# Work Order ID 88220

Item Name: Crosstube Turning Detail

DRAWING NO. D412-664-243	TITLE CROSSTUBE ASSEMBLY (412 HI AFT)	REV. E	DART AEROSPACE LTD ENGINEERING ORDER		D.E.O. NO. D412-664-243-E-1	SHEET NO. SHEET 1 OF 2	SCALE NTS
DRAWN	CHECKED <i>MP</i>	MFG. APPR. <i>E</i>	APPROVED <i>MP</i>		DE APPR. <i>MP</i>		
DATE 11.03.31	DATE 11/03/31	DATE 11.03.31	DATE 11/03/31		DATE 11-03-31

DRAWING NO. D412-664-243	TITLE CROSSTUBE ASS'Y (412 HI AFT)	REV. E	DART AEROSPACE LTD ENGINEERING ORDER		D.E.O. NO. D412-664-243-E-2	SHEET NO. SHEET 1 OF 1	SCALE NTS
DRAWN <i>q</i>	CHECKED <i>ASS</i>	MFG. APPR. <i>E</i>	APPROVED <i>MP</i>		DE APPR. <i>H</i>		
DATE 11.09.07	DATE 11.09.19	DATE 11.09.19	DATE 11.09.19		DATE 11.09.19

**D212-664-243  
ASSEMBLY DETAIL**

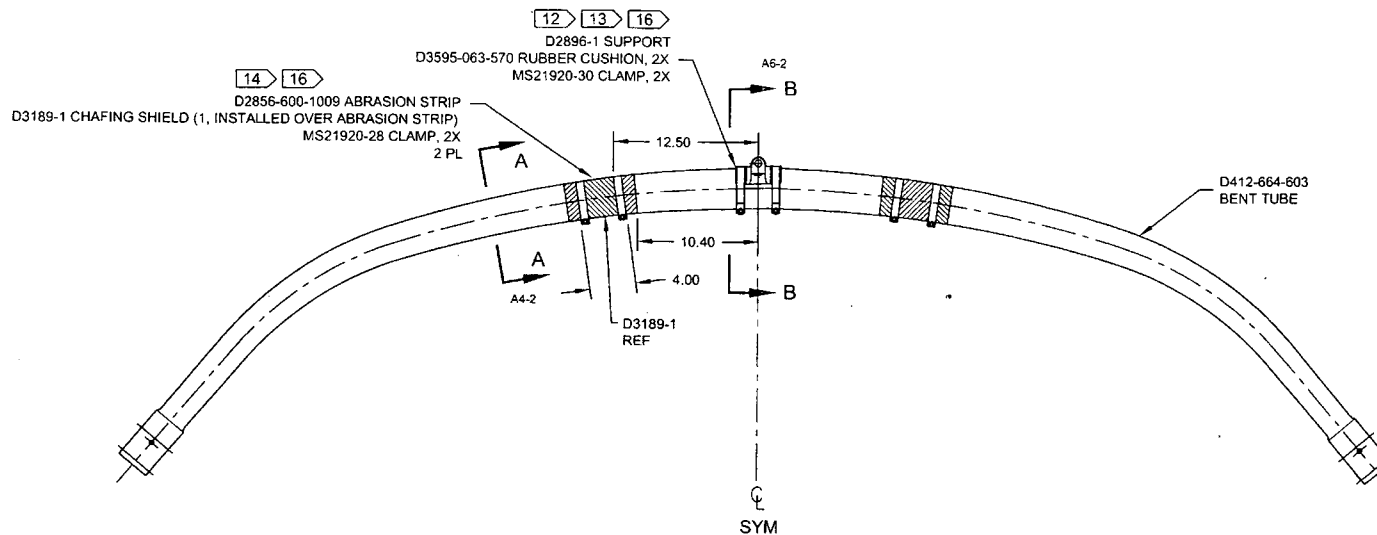
NOTES 2 AND 14, SHEET 1 ARE AMENDED AS FOLLOWS:

**IS:**

- 2) FINISH: CHEMICAL CONVERSION COAT PER DART QSI 005 4.1  
PRIME INSIDE AND OUTSIDE PER DART QSI 005 4.2  
MASK UNDERSIDE OF CROSSTUBE AS SHOWN (HATCHED AREA)  
PAINT OUTSIDE PER DART QSI 005 4.2  
AFTER PAINTING, APPLY CLEAR COAT ON HATCHED AREA
- 14) APPLY A THIN COAT OF PROSEAL 890 ON INSIDE CONCAVE SURFACE OF D3189-1  
CHAFING SHIELD AND LET CURE PER MANUFACTURER'S INSTRUCTIONS. INSTALL  
PROSEALED D3189-1 CHAFING SHIELD ONTO CROSSTUBE BY APPLYING A THIN COAT OF  
PROSEAL 890 ONTO CROSSTUBE. BE SURE TO ELIMINATE ANY AIR GAPS.

**WAS:**

- 2) FINISH: CHEMICAL CONVERSION COAT PER DART QSI 005 4.1  
PRIME INSIDE AND OUTSIDE PER DART QSI 005 4.2  
PAINT OUTSIDE PER DART QSI 005 4.2
- 14) INSTALL D2856-600-1009 ABRASION STRIPS WITH A 0.13 REF GAP ON BOTTOM SIDE OF  
CROSSTUBE PER QSI 035.
